# KENWOOD

## SERVICE BULLETIN

TS-930S CW Hetrodyne Tone

3.24.83

Figure 1

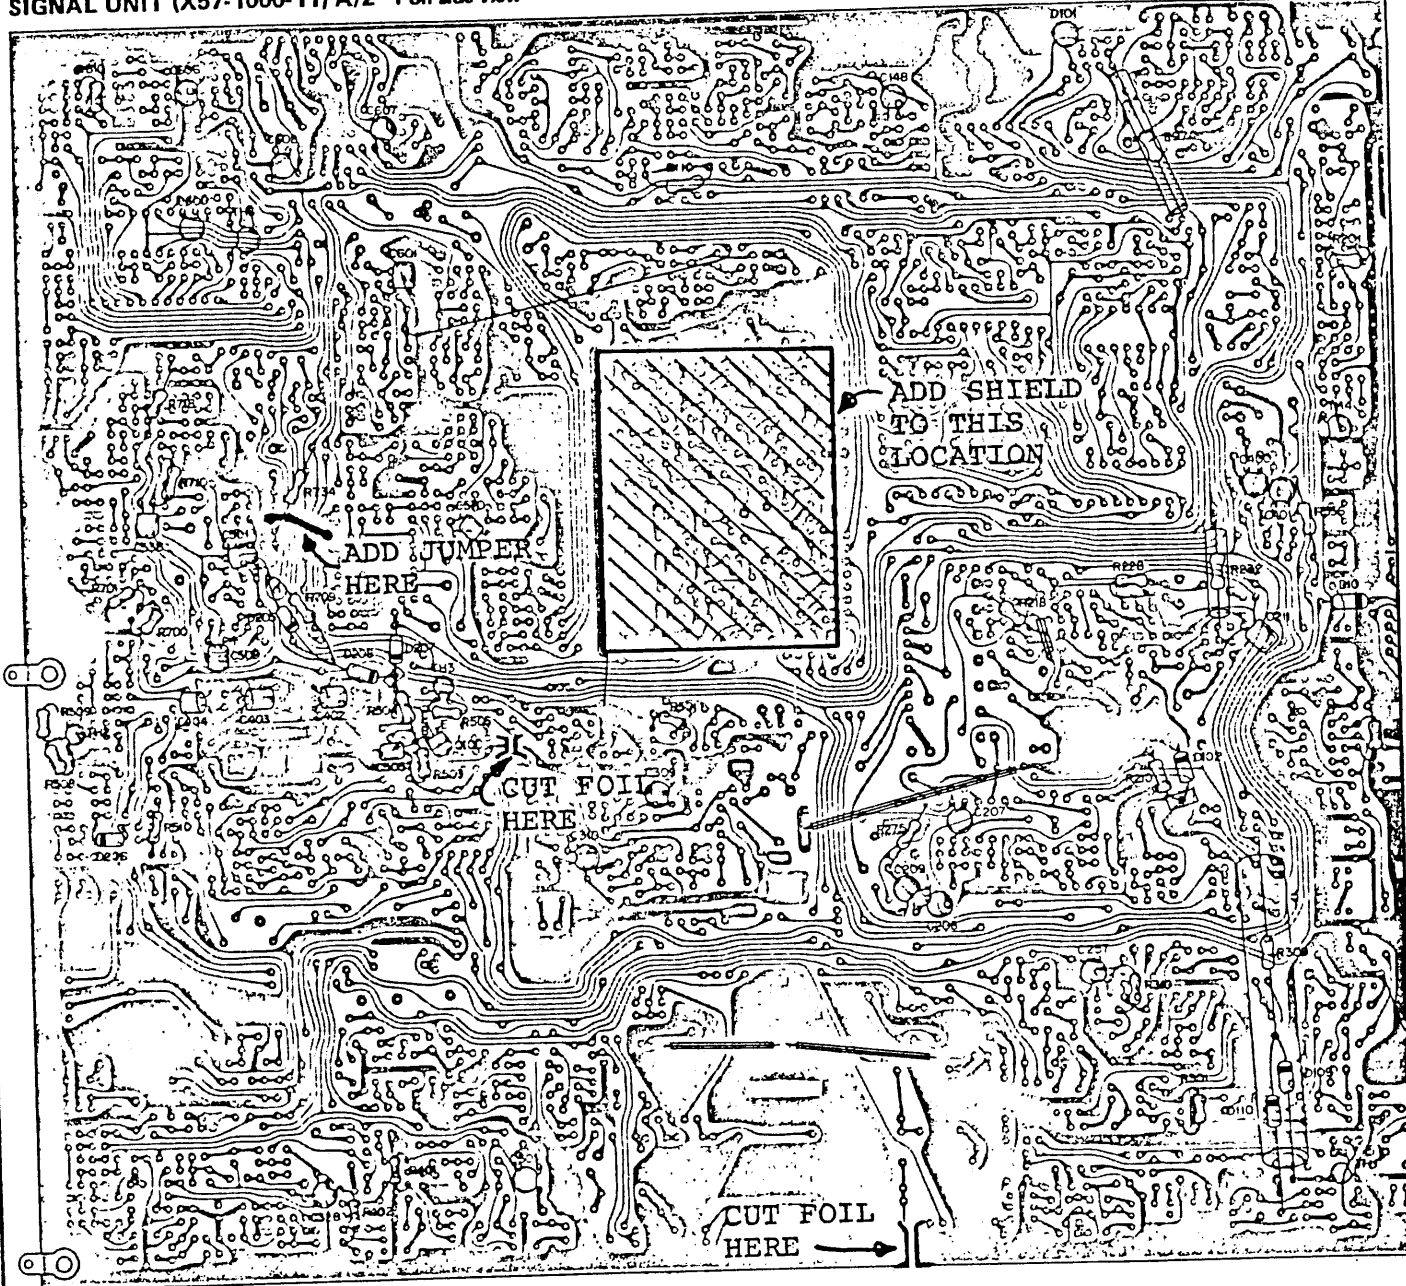
1. Remove the top and bottom covers from the TS-930S.
2. Turn the radio bottom up to allow access to the Signal Unit (X57-1000-11).
3. Remove the twenty-two (22) screws that secure the Signal Unit/Heat sink to the chassis. Unplug the RAT, DRV, XVT, FRO, and the VCOF coaxial cables from the Signal Unit. These are located along the rear and the left side of the Signal Unit. Unplug connectors number (16) and (20) located along the right of the Signal Unit.
4. Gently lift up on the rear of the Signal Unit and fold the board over towards the front panel to allow access to the bottom of the board.
5. Install the shield plate as shown in figure 1. Cut the circuit foil and add the jumper wire as shown.
6. Change the following components:

Change R635 to 8.2K $\Omega$   
Change R501 to 22K $\Omega$   
Change C469 to 3pf  
Change C473 to .5pf  
Change C476 to 1pf
